Class Rule Changes

International iQFOiL Youth and Junior Association

Status: Draft

SAIL IDENTIFICATION

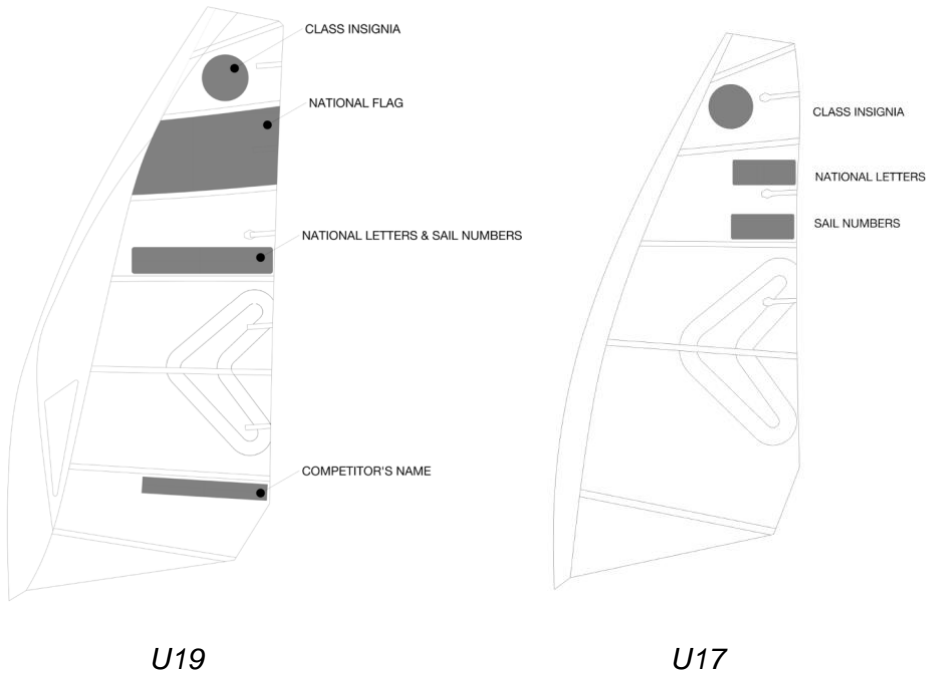
H.1 GENERAL

Replace pictures with:

U17 NATIONAL LETTERS & SAIL NUMBERS

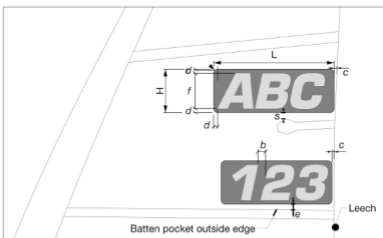
Replace pictures with:

(...) (b) Shall comply with the following specifications (see previous image)

<u>definition</u>	<u>measurements</u>
f	font size height	190mm (+-5mm)
d	distance from characters to edge of sticker	20mm (+-2mm)
H	sticker height. Result of font height and distances to edge above and below	n/a
b	distance between characters varies. Default font distance between characters	n/a
L	sticker length. Varies with different combinations of National letters or sail numbers	n/a
r	maximum radius at corners	20mm
c	maximum distance from sticker aft edge to leech tabling	5mm
e	maximum distance from sail number sticker bottom edge to outside batten pocket	10mm
s	U17 only: maximum distance from National letters sticker bottom edge to outside of batten pocket patch	10mm
